## Memorandum

**Re:** Concerns and questions on the Village Center Rezoning

**Date:** December 9, 2022

## Active and Vibrant Village Centers

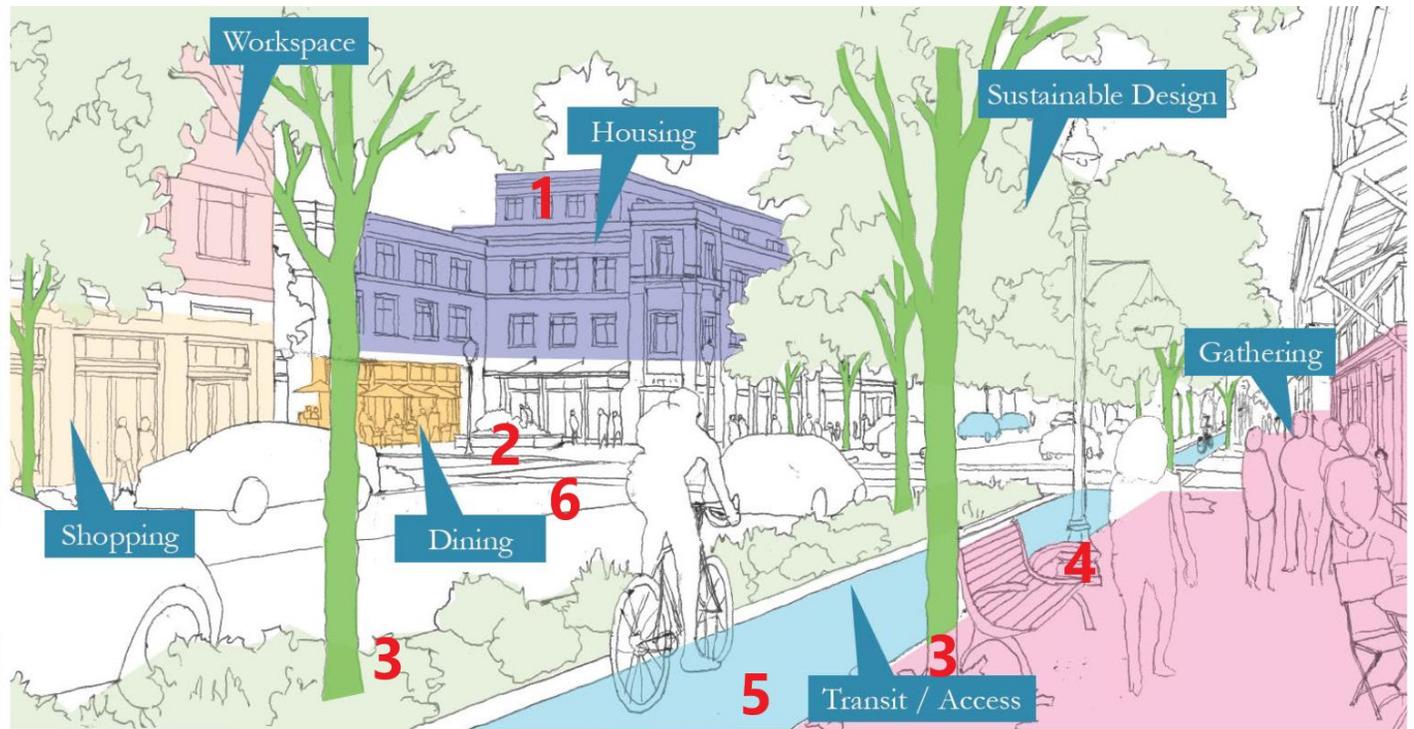
**1. The drawing that is used in multiple presentations is not an accurate depiction of the proposed zoning and should not be used.** The first page of every village presentation that the Planning Department has made contains a drawing entitled “Active and Vibrant Village Centers”. I have not identified a single Newton village that, even with full redevelopment, would look anything like this picture. It was stated at a ZAP meeting that this was a “stock” drawing. Unfortunately, residents will see this and think, “yes, this is what I want.” But the picture does not represent the proposed zoning. Please stop using it and, if you intend to use drawings in the future, use one that has a realistic depiction of what could be built under the proposed code.

Here are some examples of why this drawing is inaccurate:

1. There are no five story (or four and a half story to use your terminology) buildings in the drawing. Furthermore, the top story looks to be approximately 15 feet from the front of the building, not the proposed 7 feet.
2. The courtyard in front of the restaurant appears to be 4 bay windows deep from the sidewalk. My estimate is 4 x 10 feet, or 40 feet from the sidewalk. Per the proposed zoning, the maximum is 10 feet in VC1 or 15 feet in VC2.
3. There are 4 rows of trees along the street plus extra greenery. This could not physically fit in any of our village centers.
4. Undergrounding the overhead wires is extremely expensive. Nowhere in the proposed zoning is it required. Where are the funds to do this? With by right development there would be no extra contributions from the projects to the city for undergrounding.

5. Separate bike lanes would be great but the only village that has room to do it is West Newton and not the other 12 villages.
6. The width of this street with 4 rows of trees and two bike lanes could not fit in any of our village centers unless we bulldozed one whole side and move it back 20 feet or more.

**This picture should not be used since it does not depict a realistic village center in Newton.**

**Please provide a 3D drawing of Newtonville** in the presentations and show residents what the zoning will allow by right.
